typ modelu:
LL65XEU

Kod handlowy:
29910

Informacje Główne

N1045072FIG1

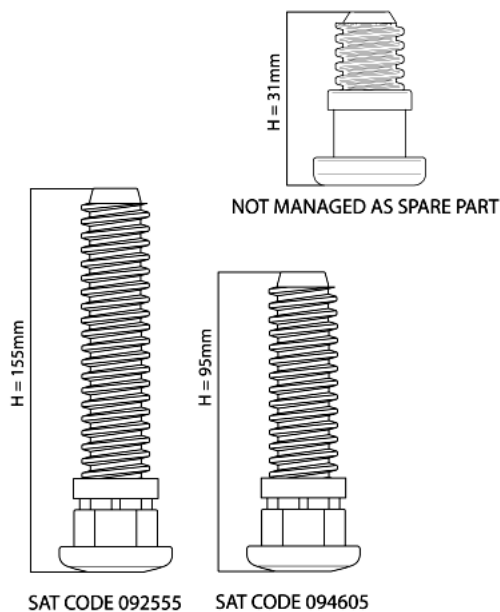
N1045072: Introduction of fixed rear foot H=31mm on free-standing models.

From serial no. 40218.0001, free-standing dishwashers affected by this modification have been equipped with new fixed rear feet (H=31mm).

The new foot replaces the adjustable one (H=155mm) Service code 092555; on the EVO3 range with TurboDry the new foot replaces the adjustable foot (H=95mm) Service code 094605.

The Spare Part Warehouse will continue to manage only 155mm and 95mm adjustable feet as they are interchangeable with the fixed 31mm foot.

The three feet are shown in illustration N1045072FIG1.

N1045069FIG1

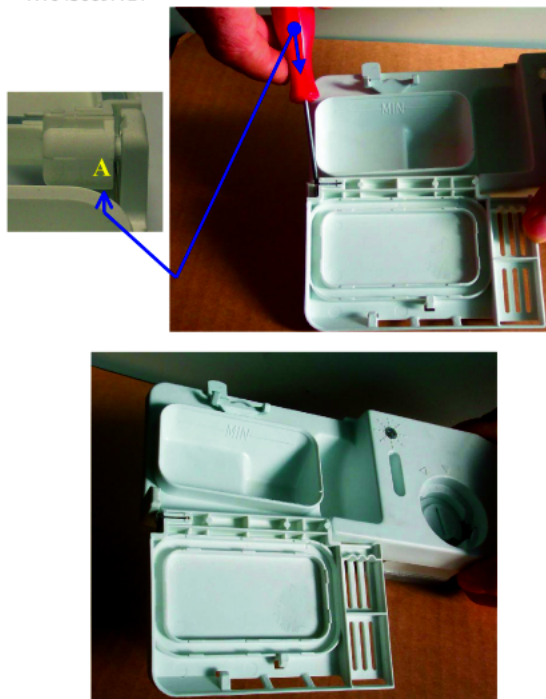
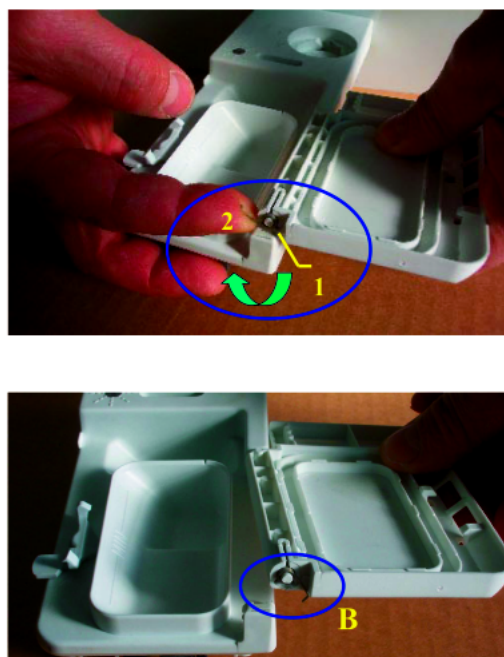
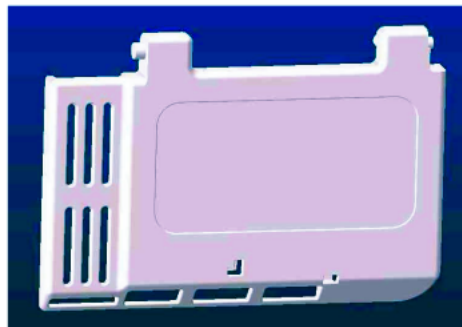
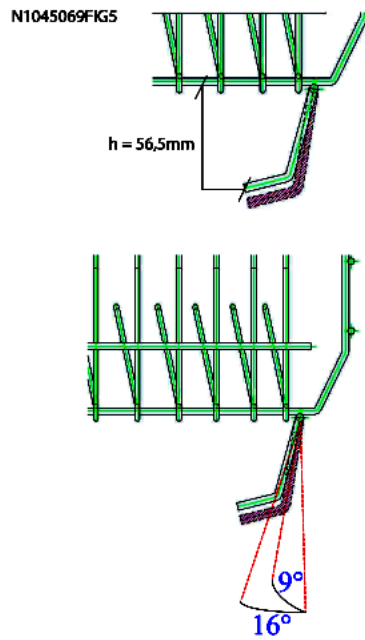
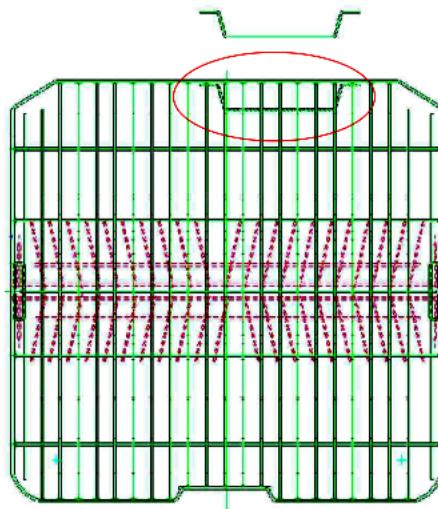
n1045069: Modification of racks and dispenser lid on EVO3 dishwashers

To obtain better dissolving of the detergent during the wash cycle, the following modifications have been made to EVO3 dishwashers:

- new dispenser lid, replacement code 098134 (see figure N1045069FIG4) created;
- upper racks modified with lid catch angle changed from 9° to 16° (see figure N1045069FIG5);
- MultiSystem lower racks modified with insertion of a spacer wire at the electric dispenser (see figure N1045069FIG6).

Lid installation instructions:

- 1) prise the lid out of the dispenser seat using a small screwdriver at point A (figure N1045069FIG1);
- 2) replace the lid, checking that release spring B (figure N1045069FIG2) is in place; before fitting the new lid load the spring from position 1 to position 2 (figure N1045069FIG2);
- 3) fit the lid in its special seat and check for correct operation (figure N1045069FIG3).

Lid closing may be harder for the first few cycles after replacement, due to settling of the material.

N1045075FIG1

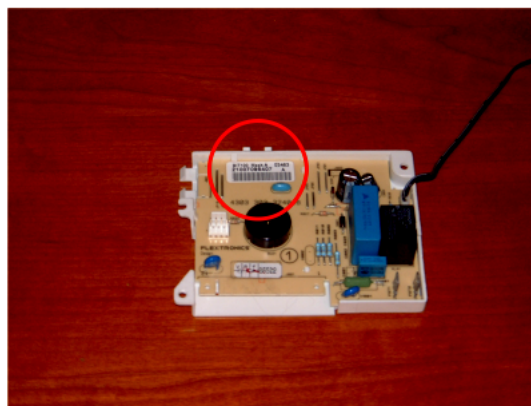
n1045075: Unification of Timer BIT 100 Service codes 097431 and 095281 with 097481.

BIT 100 "P2" TIMER (210097637.XX) Service code 097431 has been replaced with BIT 100 "E2" TIMER (210097877.02) Service code 097481.

BIT 100 "D" TIMER (210093806.XX) Service code 095281 has been replaced with BIT 100 "E2" TIMER (210097877.02) Service code 097481.

Replacement of Service codes 097431 and 095281 with 097481 is only possible with BIT 100 "E2" TIMER card code 210097877.02.

The card code is printed on an adhesive label located on the box or on the card itself (illustration N1045075FIG1).

Possible 210097877.XX card spares with modification index below 02 cannot be used for replacing, but can be used on the relevant INDESIT models (giving the BIT 100 "E2" TIMER Service code 097481 in the spare part list) until stocks last.

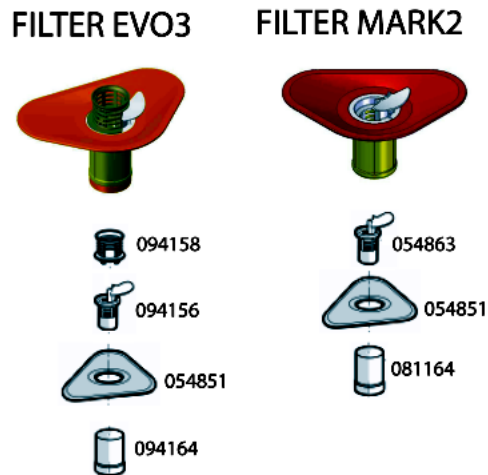
n1045083: Modification of filters on EVO3 60 cm dishwashers

All dishwasher models affected by this modification have been equipped with the items listed below, in order to solve the drain pump clogging problem.

Introduction of:

Cylindrical plastic filter code 081164

Central filter code 054863

Elimination of:

Cylindrical plastic filter code 094164

Central filter code 094156

Central filter grid code 094158

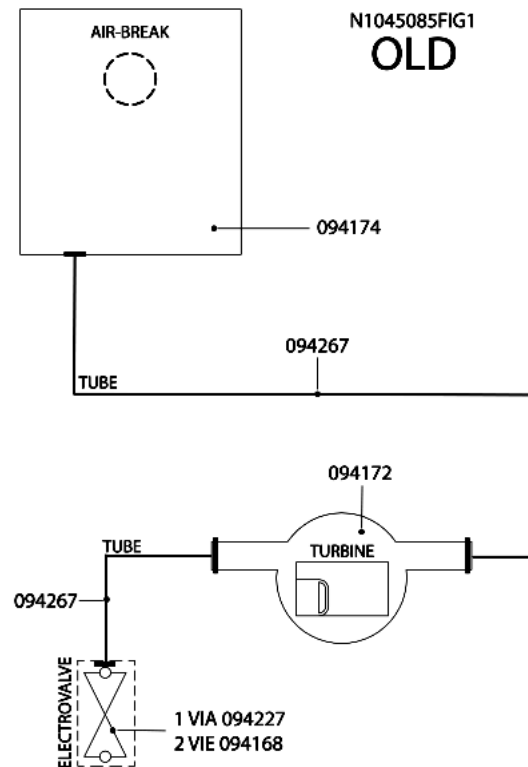
n1045085: Introduction of new litre counter turbine integrated on air-break.

All dishwashers affected by this note have been equipped with a new litre counter turbine on the air-break.

Picture N1045085FIG1 illustrates the premodification structure, picture N1045085FIG2 the new structure.

the new item features a new integrated litre counter turbine and its water supply hose has a smaller diameter.

the new solenoid valves have a smaller diameter drain hose fitting.

the new hose has a smaller internal diameter.

N1045093FIG1
NEW FLAP UPPER BASKET SAT CODE 114799

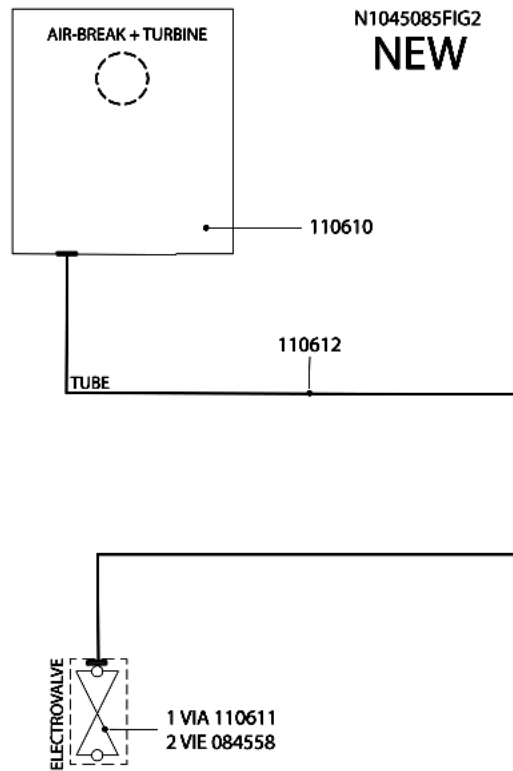
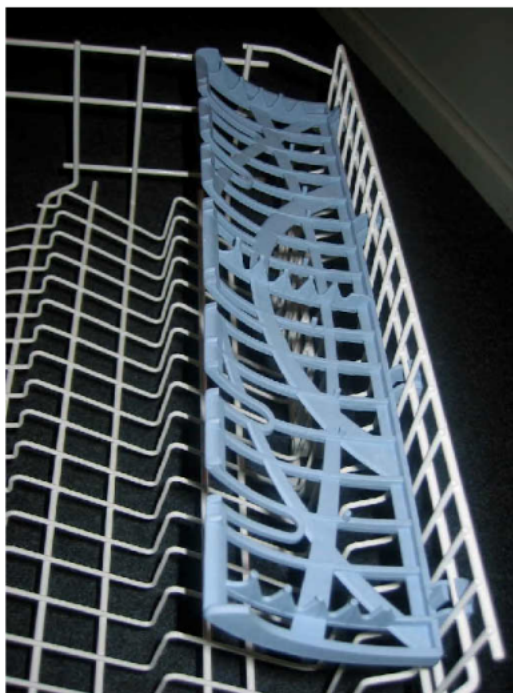
n1045093: Modification of light blue folding shelf attachment.

From serial no. 41109.0001 all models affected by this bulletin feature a modification of the folding shelf to upper basket coupling system.

This modification called for alteration of the relative baskets: the distance between the wire on which the folding shelf is attached and the wire below it has been increased from 9.5 mm to 17 mm, as shown in the attached image.

The altered folding shelves are not interchangeable and cannot be installed on premodification baskets: in the case of service interventions on product with serial number prior to 41109.0001 the entire upper basket must be replaced.

new 114799 - premodification 094140.

new 115001 - premodification 094139;
 new 115002 - premodification 094222;
 new 115003 - premodification 094233.
